Kareerand Tailings Storage Facility Expansion Project Scoping Report

Version - Final (Part 2)

GCS Project Number: 17-0026

Slime Spillage near Kuuwa

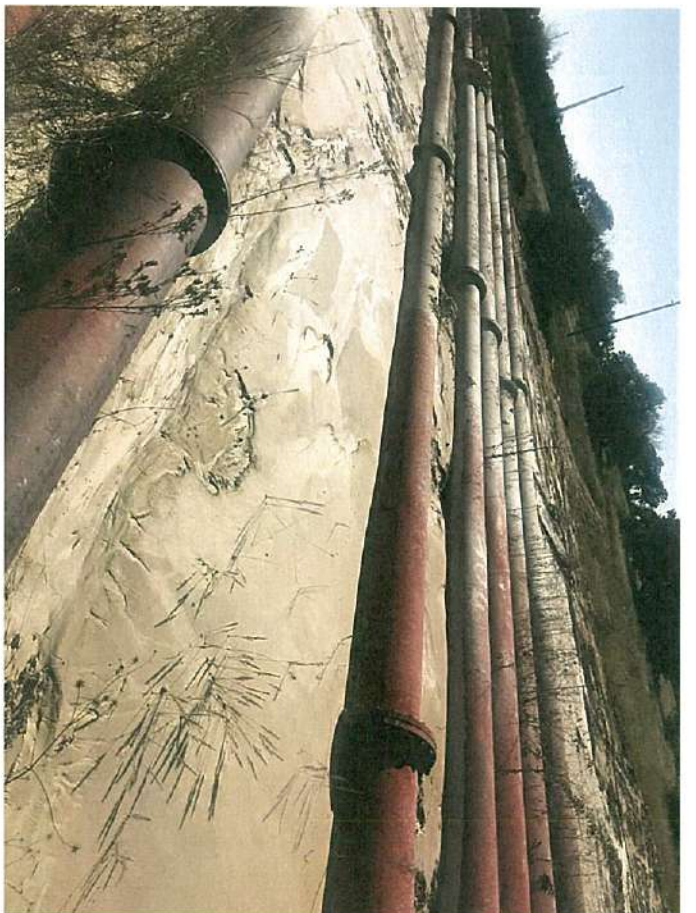
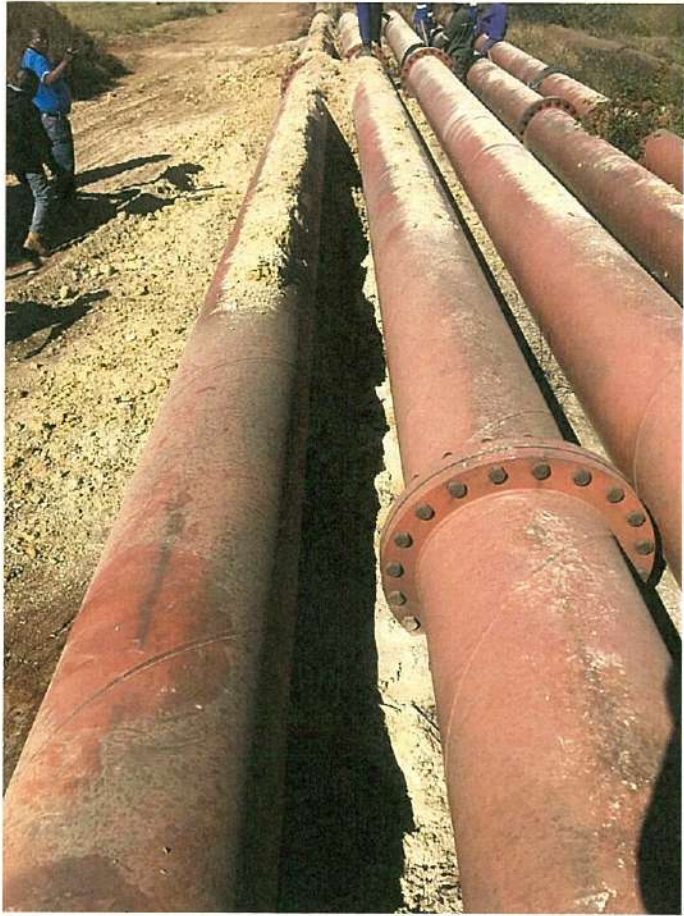
The then acting general manager Duran Archery in his medium to long term action plan report, listed plans that will prevent the risk of spillages and recurrence, but we can confirm and have proof that the spillages still occurs frequently from the pipelines, polluting our areas by spreading these toxic chemicals through storm waters, especially now in rainy seasons. And imagine such pollution happening till 2042 from these pipelines how will the grass and our plants look like? Including the health effects to the domestic animals grazing nearby, which may later slaughtered and people get sick resulting to loss of lives.
